IN THE DRAWINGS

Submitted herewith is corrected drawing Fig. 1 in which the following changes have been made:

FIG. 1

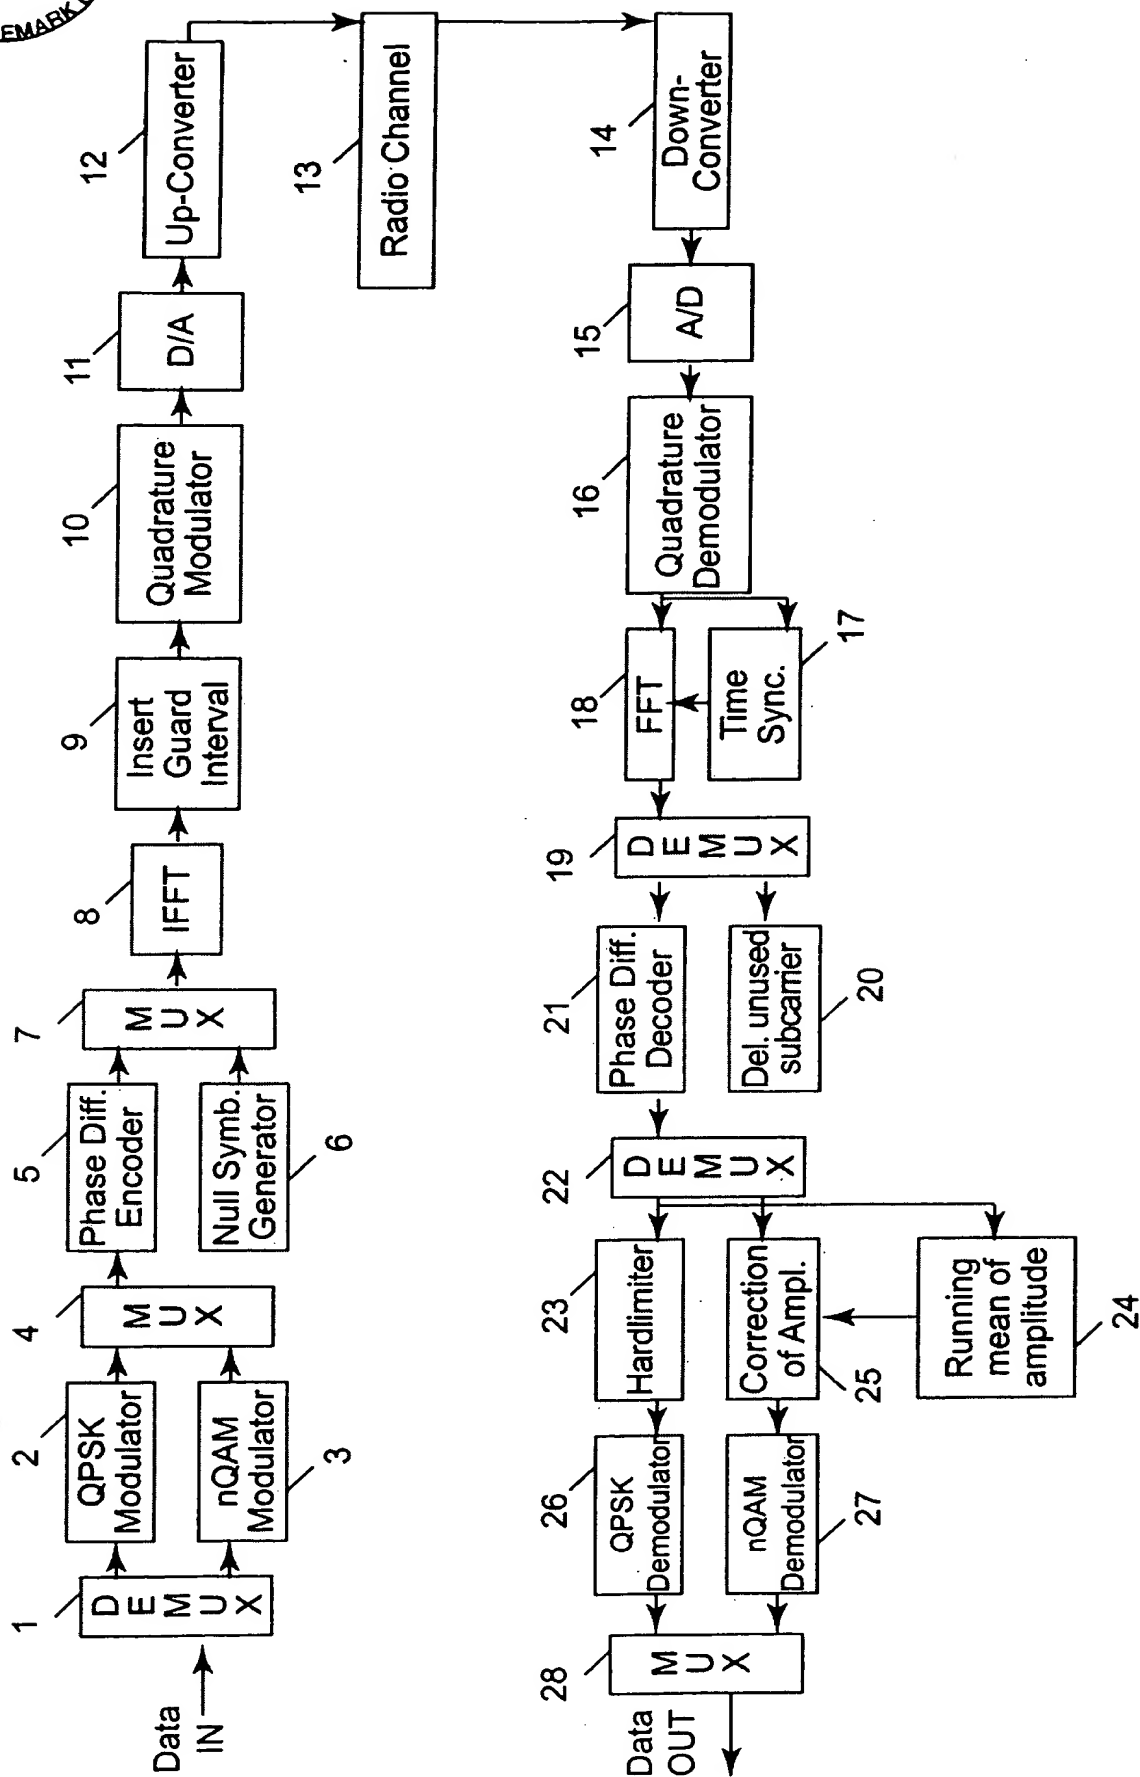
Element 16 is labeled, -- Quadrature Demodulator --; and

Element 21 is labeled, -- Phase Diff. Decoder --.
